**NAME & DESCRIPTION OF PROPOSAL:** Crossroads Bible Church Parking Lot Expansion and Reconfiguration

**FILE NUMBER:** 08-113042-LO

**City of Bellevue  
Development Services Department  
Land Use Staff Report**

**State Environmental Policy Act Threshold Determination:** **Determination of Non-Significance**

Figure 1

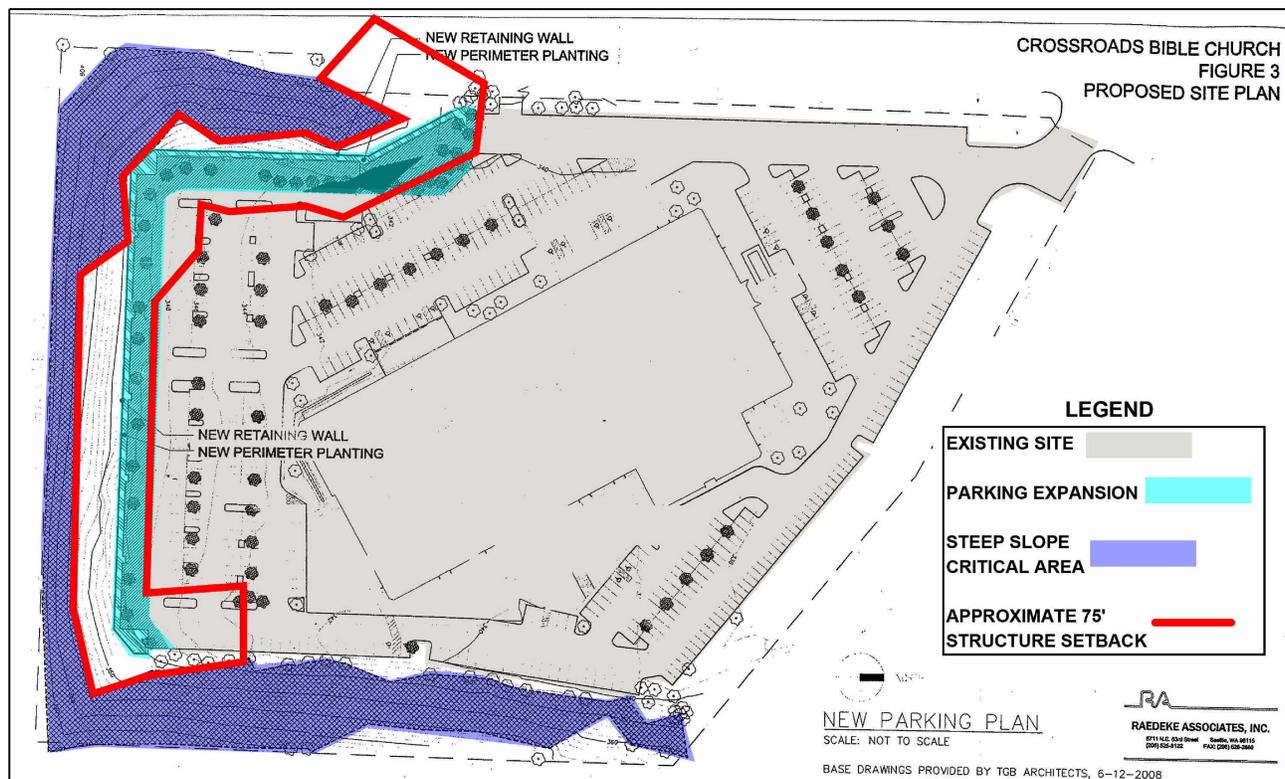
A Critical Area Land Use Permit (CALUP) to reduce the 75-foot toe-of-slope structure setback found on the site due to the presence of steep slope critical areas. The setback reduction will allow the creation of 99 new parking stalls and the construction of a retaining wall structure in an area designated as a toe-of-slope structure setback. The new parking area will be constructed with pervious pavement and mitigation planting will occur in the areas surrounding the parking lot. See (figure 1) project proposal below.

**Figure 3**

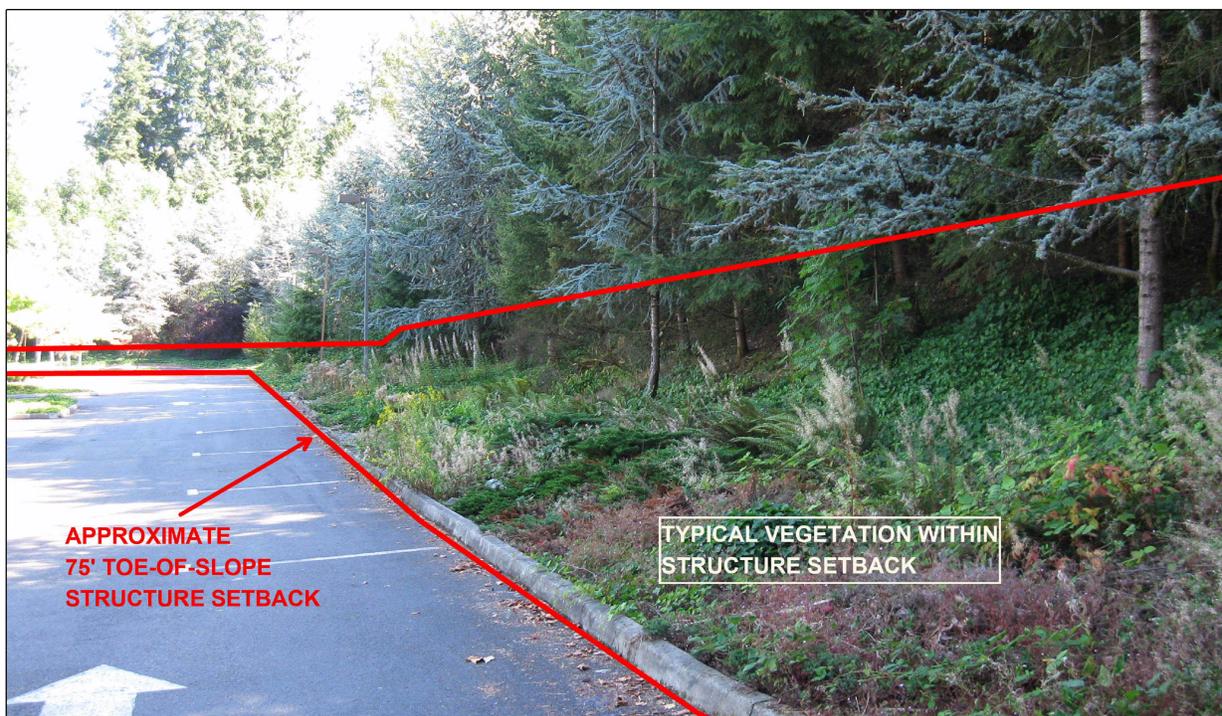
The critical area report and habitat analysis for the project site states that the vegetation found on the church site does not provide habitat suitable for any wildlife species designated as Species of Local Importance. The vegetation to be impacted is within the toe-of-slope setback and has minimal value as it is vegetated with ornamental non-native trees and invasive plants such as Himalayan Blackberry and ivy as seen in Figure 3 below which shows the southern most extent of the existing parking lot.

Based on review of the project there are no habitat functions and values provided by the toe-of-slope structure setback as the vegetation consists primarily of invasive species and ornamental landscaping. Allowing the parking lot expansion to be located in the toe-of-slope structure setback will allow the more mature vegetation on the steep slope critical areas to remain undisturbed. The proposed retaining wall will support the steep slopes and will remain outside of the steep slope critical areas, causing only temporary disturbance that will be mitigated. In addition plants consistent with the City's Critical Areas Handbook for steep slopes (see attachment 1) will be planted as mitigation in the steep slope critical areas for the allowed development in the structure setback. To further reduce impacts to the site the proposed parking lot expansion is to be pervious

Figure 4

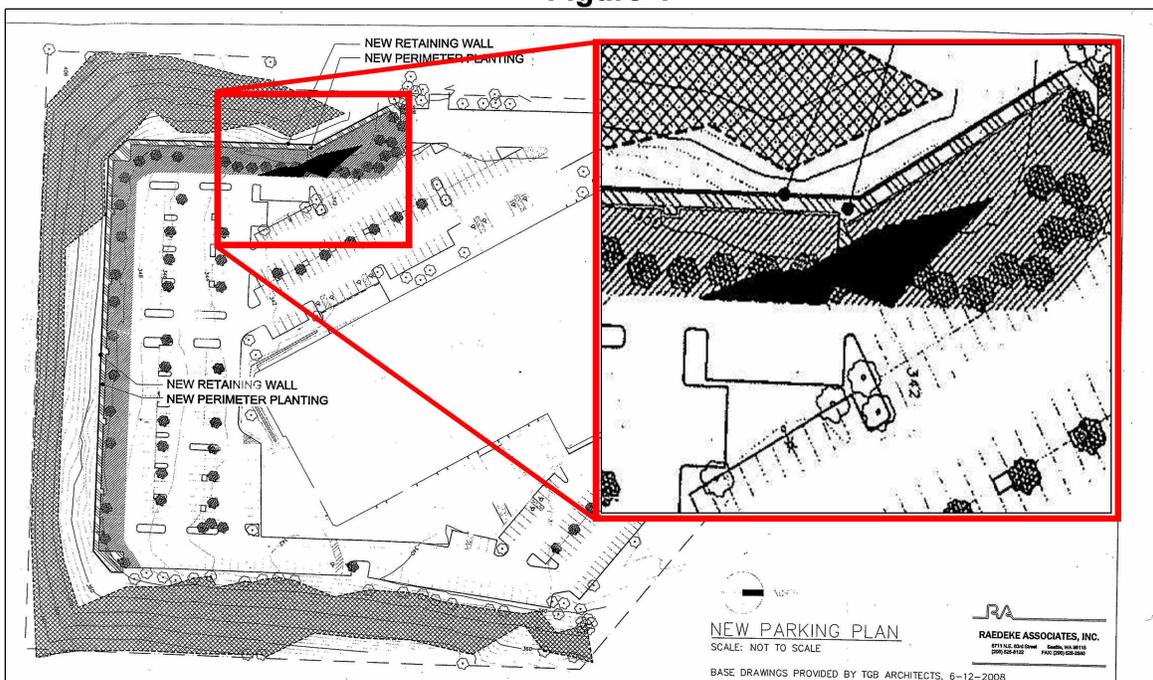
Geologic Hazard Areas (GHAs) are defined by the City of Bellevue Land Use Code as: those areas with slopes of 40 percent or more that have a rise of at least 10 feet and exceed 1,000 square feet in area. There is an isolated pocket of steep slope that is depicted as being 40 percent or greater located on the southwest portion of the site that is proposed for removal by the parking lot expansion. However, according to the project geotechnical report prepared by ZZA-Terracon dated July 30, 2008, this steep slope area does not meet the criteria in the Land Use Code to be categorized as a critical area, thus per the definition of steep slopes above this pocket of steep slopes is not considered a GHA and critical area. See Figure 4 below which depicts the pocket of steep slopes (black polygon) located in the proposed parking lot expansion.

Figure 4

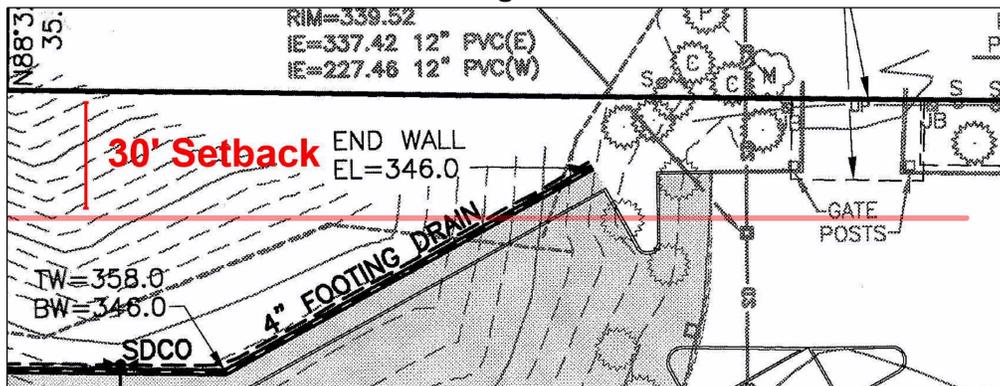
In order for the parking lot to be expanded as proposed a retaining wall is to be constructed to support the steep slopes which ring the site to the south and east. Retaining walls are allowed in setbacks provided that they are 30 inches or less in height. At one location seen below in figure 4 the retaining wall is within the required 30-foot side yard setback from the western property line. A condition for approval will be that the height of the wall within the setback is 30 inches or less. See Conditions of Approval in Section XI of this report.

The height of the proposed retaining wall within the required 30-foot side yard setback shall be 30 inches or less. A building permit will be required and the wall may be subject to other requirements in LUC Title 20.
